Fire Management Report for Development of ERF 3122 - Hartenbos

Annexure 2: Fire constraints map

Annexure 3: Development proposal and fire scoping comments

Skaal	NTS	Leer nr.	H 10-113
Teken	PJLR	Datum	MARCH 2023
Keur	PJLR	Tekening nr.	H 10-113 SUB 1-REV 13

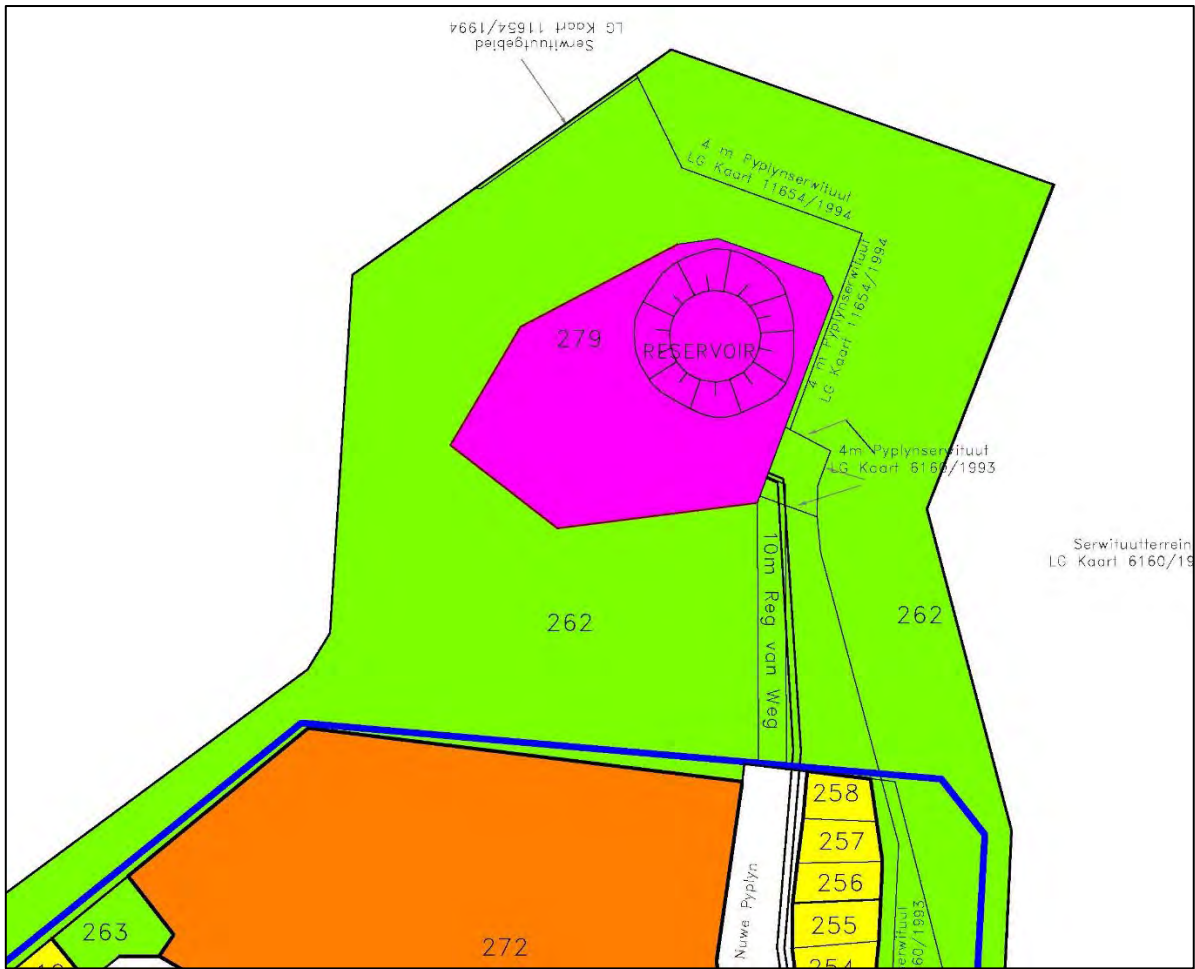
- 9.8.1. Notably in “alternative 3” the fence line of the property is moved effectively joining the area to the adjacent conservation area of the municipality.

- 9.8.2. The fire buffer on the actual property boundary must remain as indicated in the original fire constraints report. This serves as a

strategic point from where controlled burns can be anchored or alternatively from where counter fires can be started to protect from external threats (by qualified, adequately equipped fire managers only).

9.8.3. "Alternative 3" is the final layout.

Annexure 12: Plot 270 fire management unit

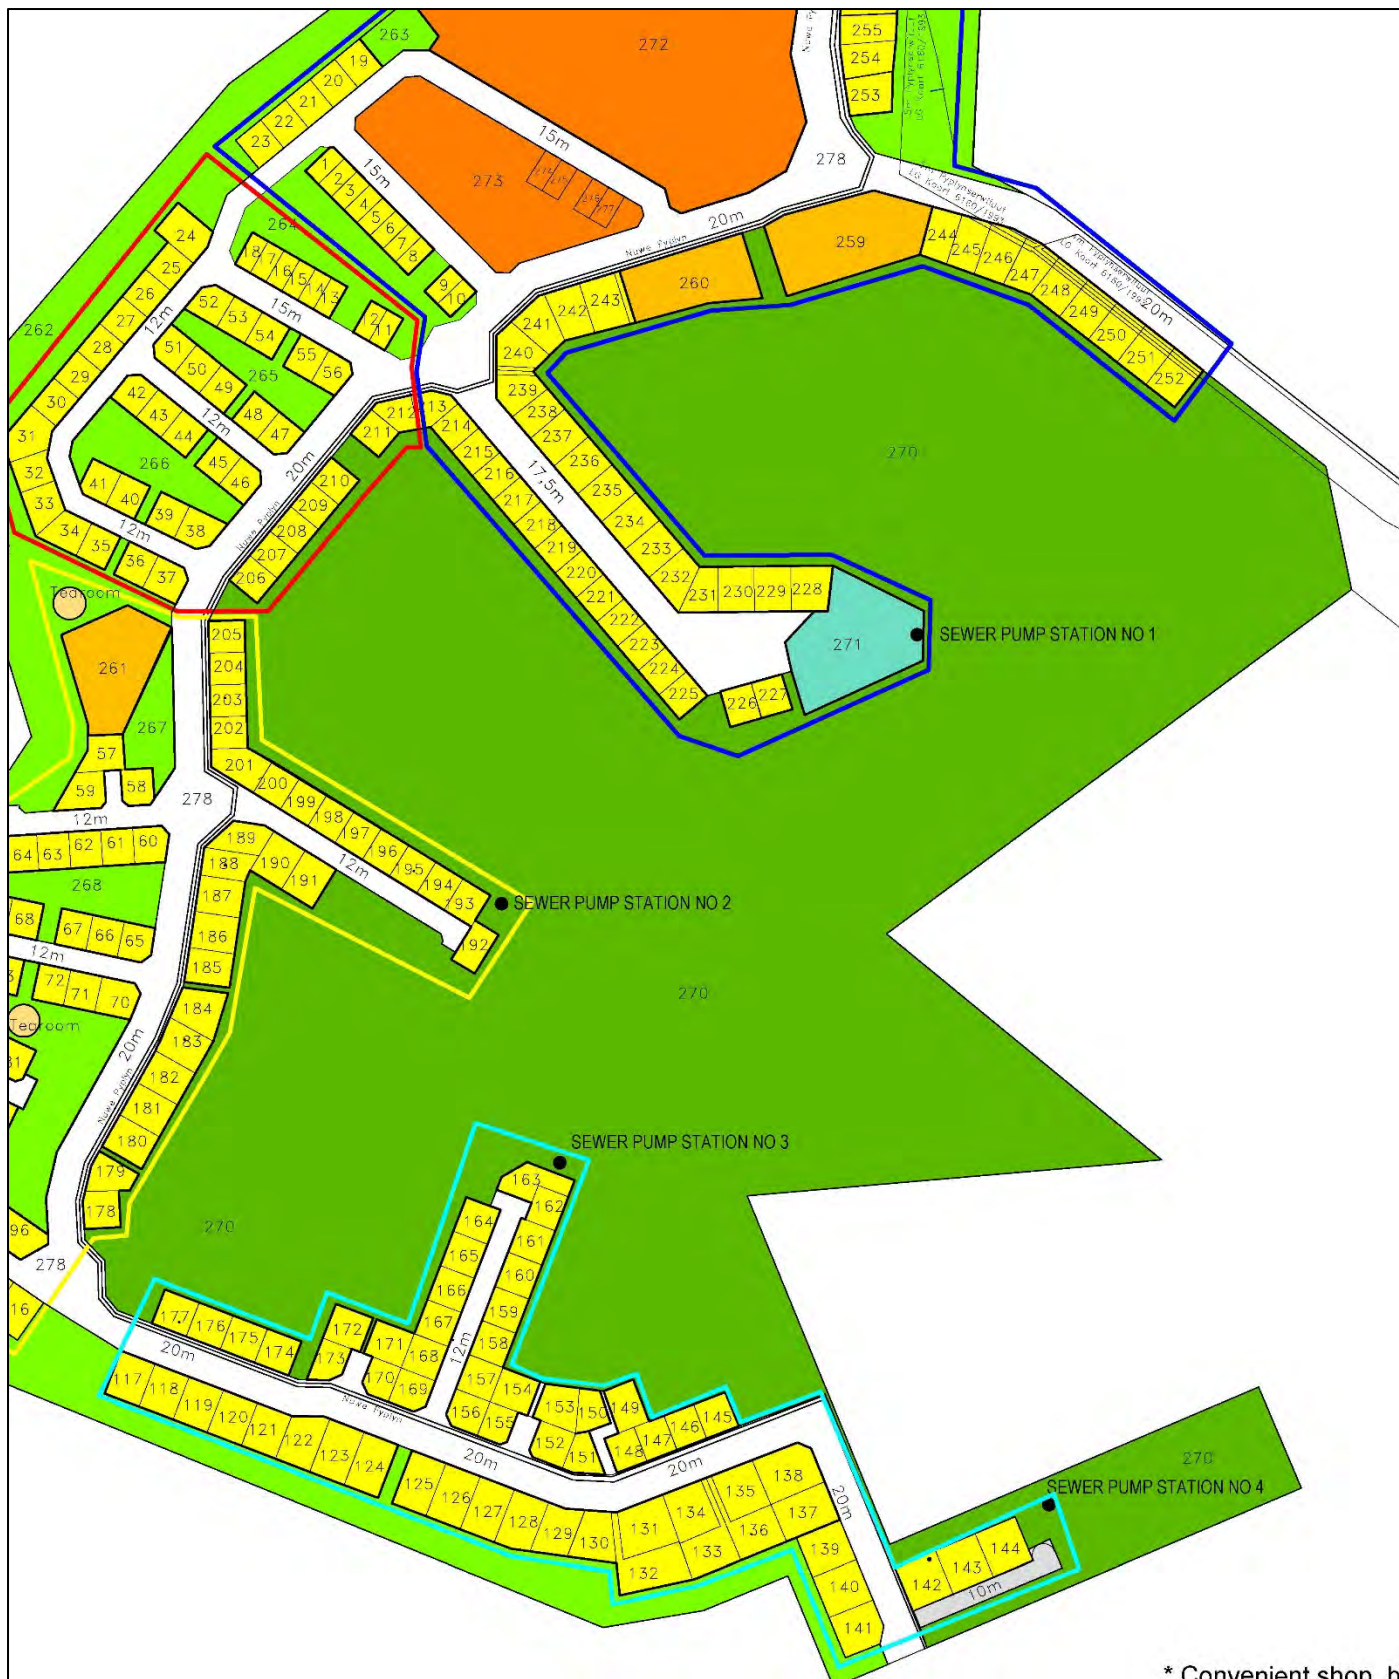
10.1.2. The area east of the residential development that extends down into the drainage lines marked as plot 270 on the final layout (Annexure 12).

10.1.2.1. The simplest solution would be to regard this section as a single fire management unit. The total area of the section is approximately

20 ha.

- 10.1.2.2. Alternatively, the area can be divided into two or three smaller units using the drainage lines as logical dividing lines. For example, making a north / south separation through the drainage line north of sewer pumpstation 3 (Annexure 13). This would result in two roughly equal sized sections with an approximate area of 9 and 11 ha respectively.
